1986 - 1987 Corvette: Service Bulletin: Clutch Master Cylinder Push Rod Bushing

Subject: Clutch Master Cylinder Push Rod Bushing
Model Year: 1986 - 1987 Corvette with Manual Transmission
Source: Chevrolet Dealer Service Bulletin
Bulletin No: 87-114, Section 7C
Date: April, 1987

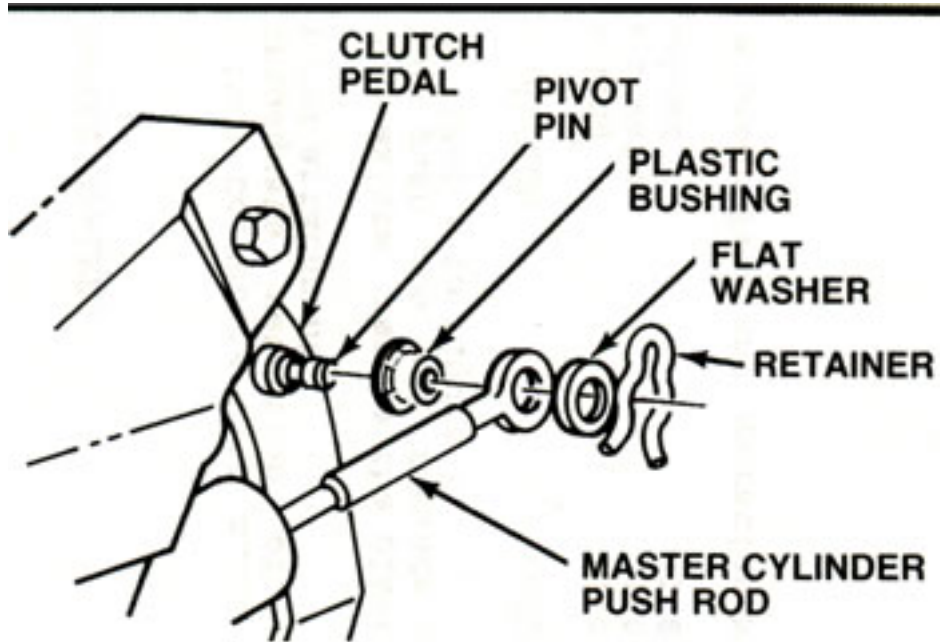
Some 1986 or 1987 Corvettes with manual transmissions may experience inadequate retention of the clutch master cylinder push rod attachment.

If the condition exists, remove the plastic bushing from the master cylinder push rod and replace with the following service parts. (Refer to Figure 1):

| DESCRIPTION | PART NUMBER |
| Bushing | 14080233 |
| Flat Washer | 120395 |
| Retainer | 148149 |
